UPDATES

GaAsFET Preamp Sequencer

See the above article on page 8 of the March 1992 issue by Ron Klimas WZ1V. Although the schematic is cor-

Figure. Partial schematic of the GaAsFET preamp sequencer showing new IC pin numbers corresponding to the PC board layout.

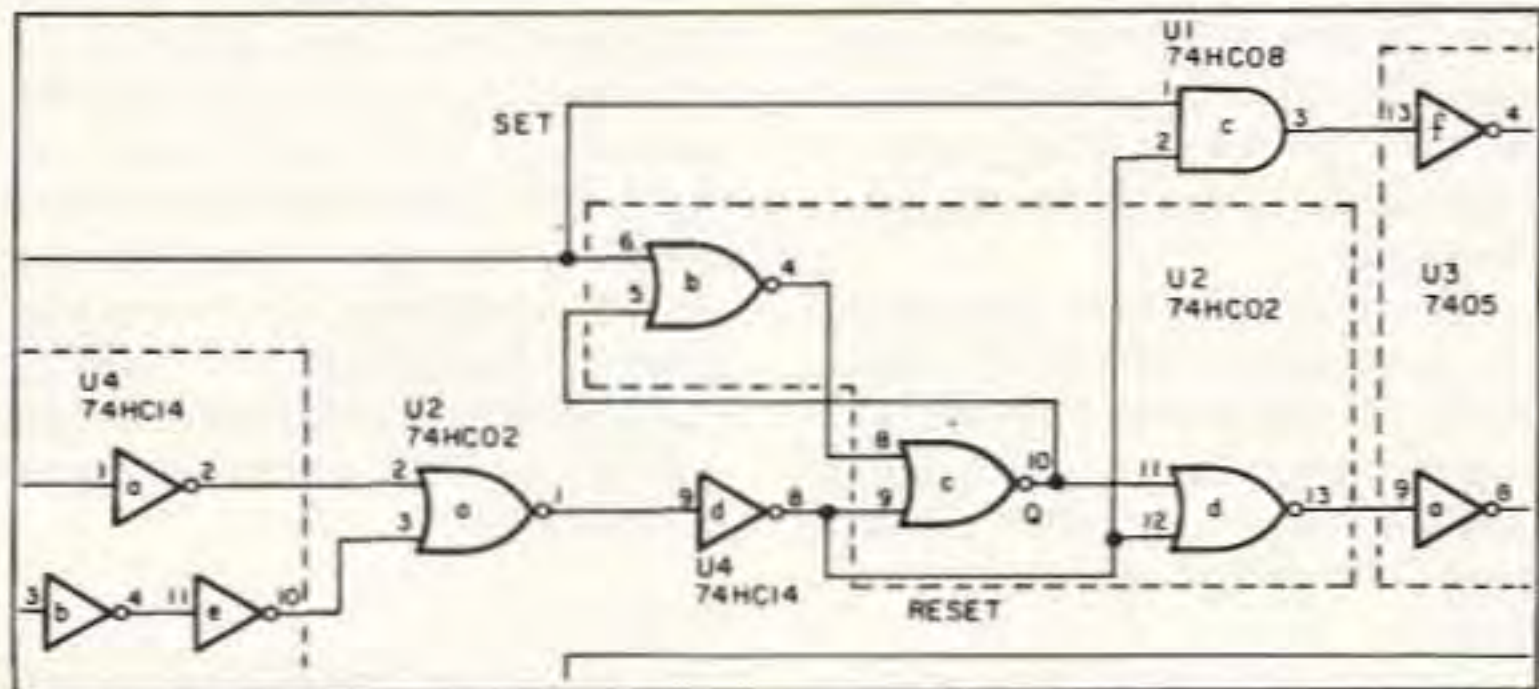
rect as printed, if you build the circuit using the PC board the IC pin numbers will be different. See the Figure for a schematic that reflects the pin number changes on the PC board layout. **73**
